SPECIALIST CONSULTANCY SERVICES AT HDB DEVELOPMENT (WESTERN)

Tengah North EMMP Consolidated Addendum (Area A)

Housing & Development Board (HDB)

Date: 4 November 2024

Figure 6-1 The Extent of Additional Earthworks Footprint outside Tengah Earthworks Phase 3

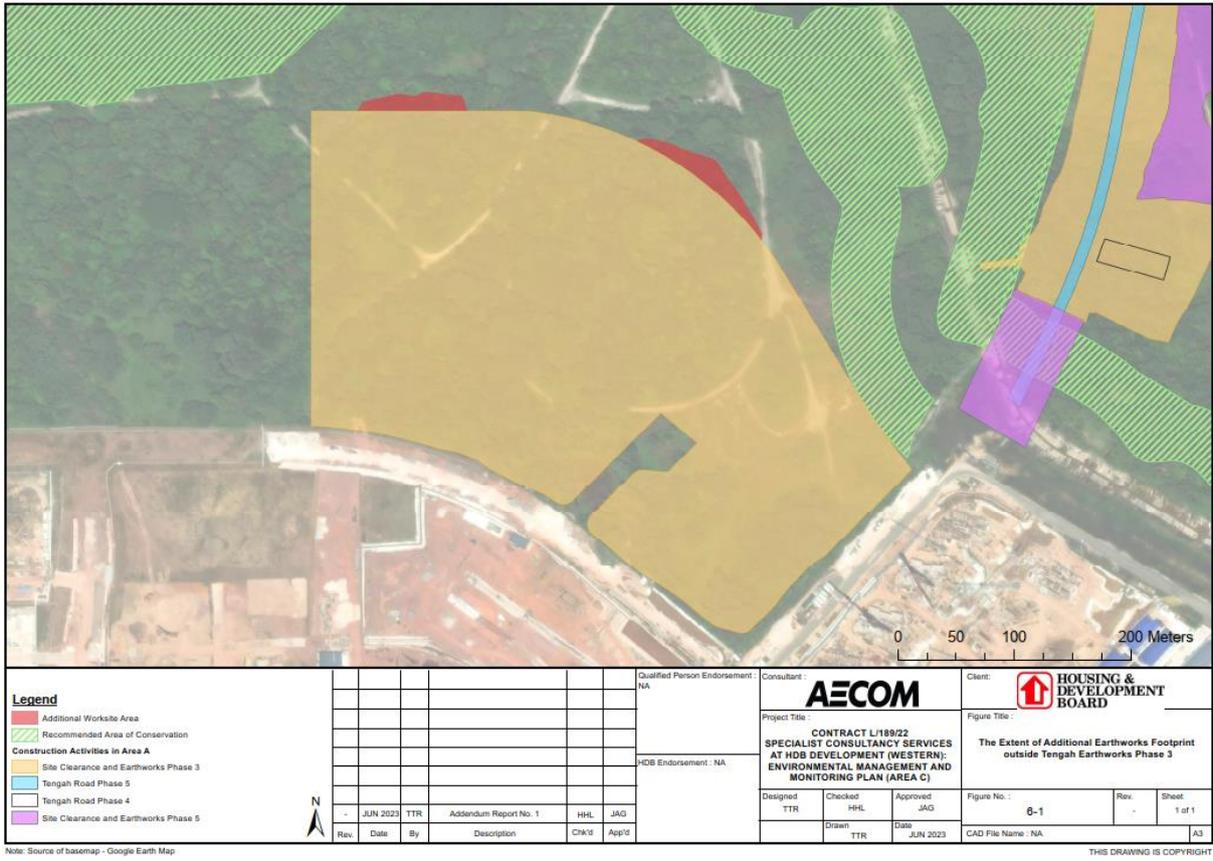
Due to the terrain within Tengah Earthworks Phase 3, certain extent of additional earthworks are required on the northern side of Tengah Earthworks Phase 3. Subsequently, SI works will also be required on the northern side of Tengah Earthworks Phase 3. Refer to Figure 6-1 on the additional earthworks worksite area required. Due to the additional worksite, additional tree clearance would be required. This is a deviation to the approved EMMP Report for Area A as there was no plan for vegetation clearance within this area.

Relevant mitigation measures applicable to Tengah Earthworks Phase 3 (vegetation clearance and earthworks activities) in Sections 6, 7 and 10 of the approved EMMP Report for Area A will apply to this additional area. If any fauna is encountered during the clearance, wildlife response plan shall be adhered to. Tree felling approval for these additional trees will be obtained separately by HDB's earthworks consultant. Affected trees planned to be cleared is provided in Appendix C.

With regards to SI works, there will not be any deviation from the previously agreed arrangement with NParks. SI works will start for areas that have been already cleared by earthworks contractor. No additional clearance to be done for SI boreholes worksites or access routes. The location of SI boreholes is provided in Appendix C.

Appendix B Affected Trees within Forest Fringe

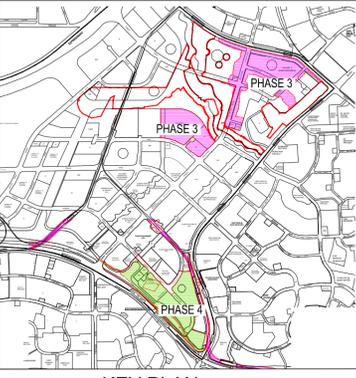
Based on email exchanges between HDB and NParks dated 19 December 2022, NParks is agreeable to the proposed platform level for BTO plot and the adjacent forest fringe, and NParks proposed terraced design for the Forest Fringe to ensure slope stability and increase area of planting. Also, NParks requested HDB to study a covered linkway design that would fit the terraced Forest Fringe design and not hinder animal movement through Forest Fringe. After the assessment done by HDB's earthworks consultant for Tengah Earthworks Phase 3, some trees would need to be cleared to facilitate the terraced design. This is a deviation to the approved EMMP Report for Area A as there was no plan for vegetation clearance within the Forest Fringe.

During this additional clearance, relevant mitigation measures applicable to Tengah Earthworks Phase 3 in Sections 6, 7 and 10 of the approved EMMP Report for Area A will apply to this additional area. If any wildlife is encountered during the clearance, wildlife response plan shall be adhered to. Tree felling approval for these additional trees will be obtained separately by HDB's earthworks consultant. Kindly refer to Appendix B on affected trees planned to be cleared within the Forest Fringe.
